This paper was co-presented by Dr Thomas Hardy in Trondheim, Norway on June 23, 2014, two months *before* the first public discussion in San Marcos, TX was held about the possibility of removing Cape's Dam from the San Marcos River.

ASSESSING POTENTIAL REMOVAL OF TWO LOW-HEAD DAMS IN AN URBANIZED TEXAS KARST STREAM

Figure 5. Predicted fountain darter WUA (m²) within the study area of the San Marcos River at discharges of 1.28, 2.83, 4.90, and 8.50 cms for three dam scenarios including full dam height (black bars), half dam height (gray bars), and no dam (white bars).

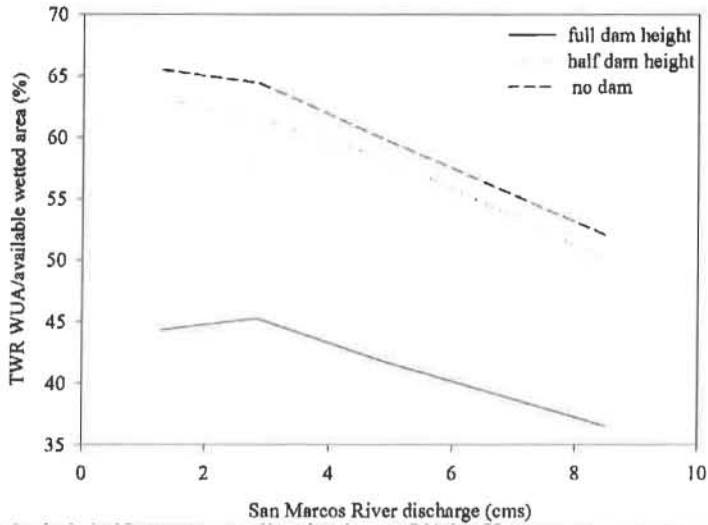
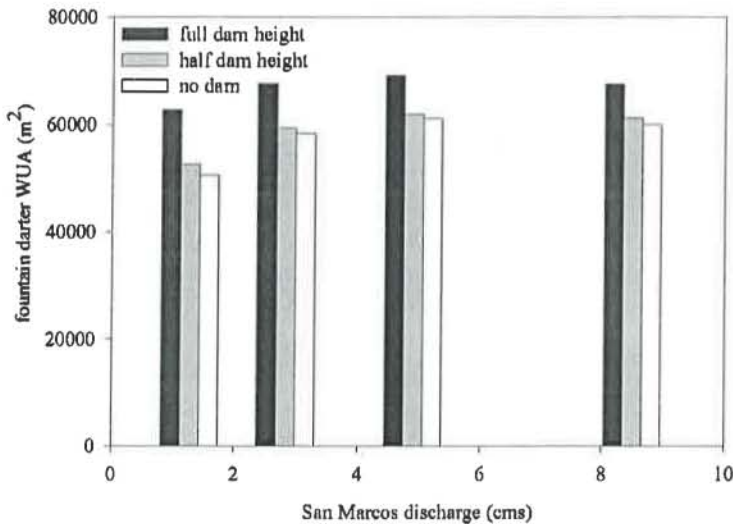
4th flow rate of 300 cfs is included in this chart, but it is omitted from the CoSM's 2015 reports, even though all 4 flow rates are specified in Contract with city.
